NEW DESIGNS & INNOVATIONS

MODEL 10101 & 10102

REDESIGNED SEQUENCE VALVE - Adjustable and Longer Lasting...

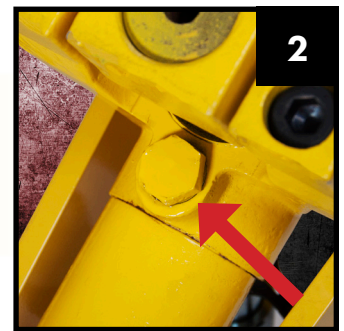
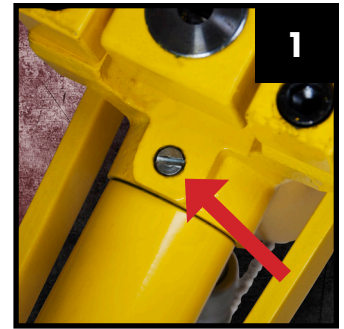
The "Sequence Valve Screw" has been redesigned to better aid in both usability and eliminating potential issues while the product is in use on the Wheel Assembly (1).

- ▶ **PROBLEM:** The Old Design Nut (2) would get damaged during the use of the tool. This damage would then make it difficult to service the bead breaker and/or adjust the sequencing of the bead breaker, eventually putting the bead breaker "out of service".

In addition to damaging the sequence screw over time, the spring inside of the bead breaker loses strength and clamping force weakens, resulting in the need to replace the spring or "shim" the spring with a washer, which is NOT recommended. This may also result in leaking of the valve body.

- ▶ **SOLUTION:** ESCO has redesigned the Sequence Valve Screw to a recessed adjustable set screw (1) that not only keeps the screw completely out of the way during the use of the tool but, also makes it a much more convenient solution for "adjusting" the sequence of the bead breaker while out in the field*.

***NOTE:** It is possible to OVER TORQUE the Set Screw. This will result in damaging the tool or even the wheel assembly. Mark where you started with the set screw and adjust in "quarter turns" **ONLY**.

LOCK JAW PIN "SET SCREW" - More Control & Better Bites

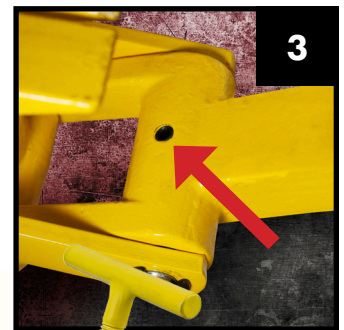
ESCO has redesigned the "JAW" to create a much stronger and stabilized gripping of tool onto wheel assembly (3).

- ▶ **PROBLEM:** The jaw of the bead breaker, due to its design, has some "give" allowing for it to move from side to side. This then will cause the bead breaker to grab onto the wheel assembly at an angle, causing potential scarring of the internal rams that operate the bead breaker.
- ▶ **SOLUTION:** ESCO has added an additional "set screw" (3) that clamps the jaw onto the pin centrally so that there is no movement on the jaw. This in turn will keep the bead breaker aligned straight, aiding in removing a potential for damage to the unit, giving a more precise grasp onto the wheel assembly.
